REPLACEMENT SYSTEM VARIANCE REQUEST

System's Location: RR 1 PULLEN ROAD AUGUSTA, ME 0433 0 Tel. No.: 626-2811

SUBSURFACE WASTEWATER DISPOSAL SYSTEM APPLICATION

SUBJECT: Approval Replacement System Variance Request, Dipman property, Pullen Road,
Augusta

SITE PLAN

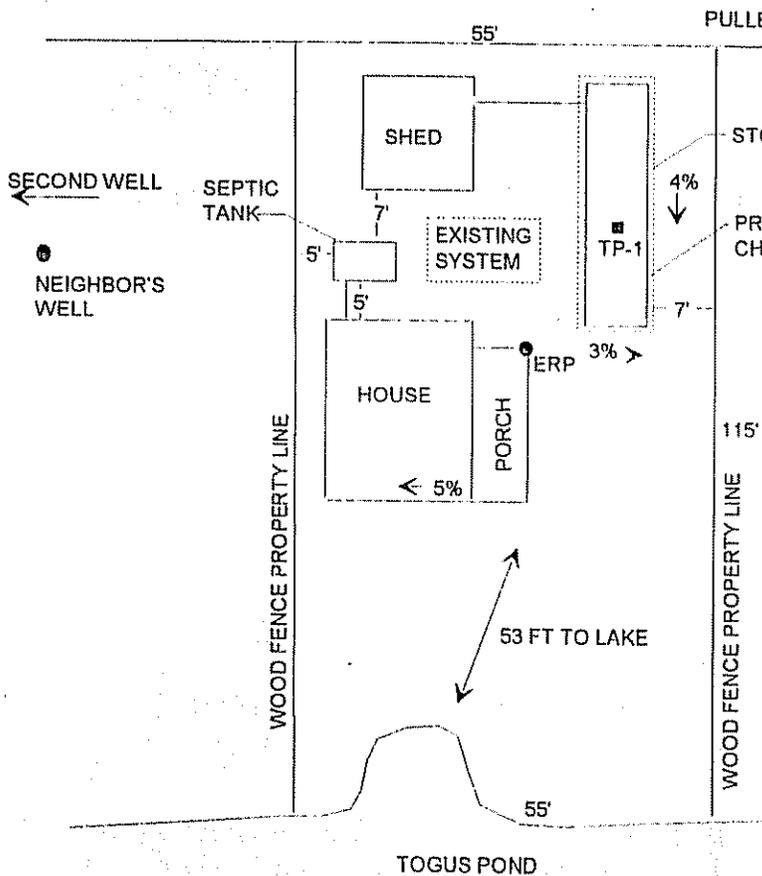
TWO NEIGHBORING WELLS ARE NEARBY THE PROPOSED SYSTEM, HOWEVER, THE NEW SYSTEM COMPONENTS ARE NO CLOSER TO THE NEIGHBORING WELLS THAN THE SYSTEM THAT IS BEING REPLACED

DISPOSAL SYSTEM TO NEAREST WELL = 66 FEET
DISPOSAL SYSTEM TO FURTHER WELL = 103 FEET
SEPTIC TANK TO NEAREST WELL = 31 FEET
SEPTIC TANK TO FURTHER WELL = 67 FEET
DISPOSAL SYSTEM TO LAKE = 53 FEET
SEPTIC TANK TO LAKE = +50 FEET

STATE VARIANCE REQUESTED TO SITE THE REPLACEMENT SYSTEM 53 FEET FROM LAKE

The Division has reviewed a replacement system variance request for the subject property. The specific state variances requested are to allow the installation of a subsurface wastewater disposal system with reduced setbacks of 53 feet between the disposal field and a major watercourse and 31 feet between the septic tank and an abutter's well. The system design prepared by William Brown, SE, dated 7-15-97, is found to be in compliance with the Maine Subsurface Wastewater Disposal Rules.

We approve the requested variances with the following requirements:

1. A permit for system installation is to be obtained from the Local Plumbing Inspector in advance of the start of system construction.
2. The system is to be installed in accordance with the submitted and approved system design. Should any changes or alterations be required at the time of construction, the system designer is to be notified prior to making the changes.

SUBSURFACE WASTEWATER DISPOSAL PLAN

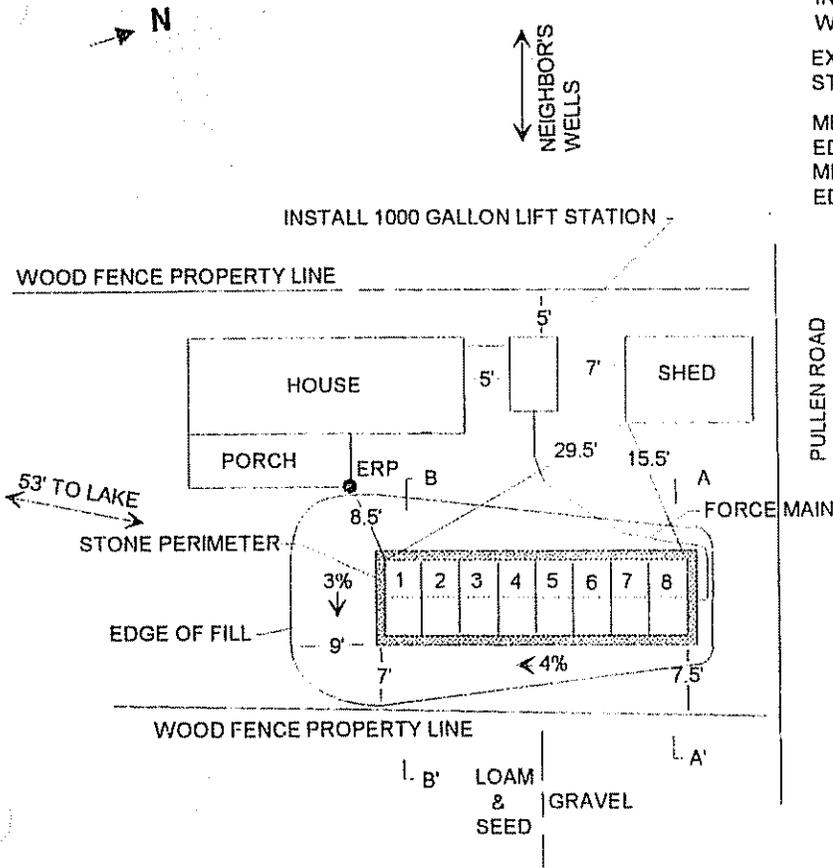
1. Fill extension Grade - to 3:1 **REDUCE SLOPE OF FILL TO 3 TO 1 ALONG SIDE OF SYSTEM NEAR PROPERTY LINE TO MAINTAIN FILL ON PROPERTY AND NEAR PORCH TO ALLOW ROOM TO DIVERT SURFACE WATER AWAY FROM HOUSE**
2. **TO DIVERT SURFACE WATER AWAY FROM HOUSE**
3. **THERE IS NO PRACTICAL ALTERNATIVE**

STEEPEN SLOPE TO 3 TO 1 AS NECESSARY TO AVOID FILL ON NEIGHBORING PROPERTY ALONG ONE SIDE OF SYSTEM AND NEAR PORCH TO ALLOW SURFACE DRAINAGE TO FLOW BY THE HOUSE
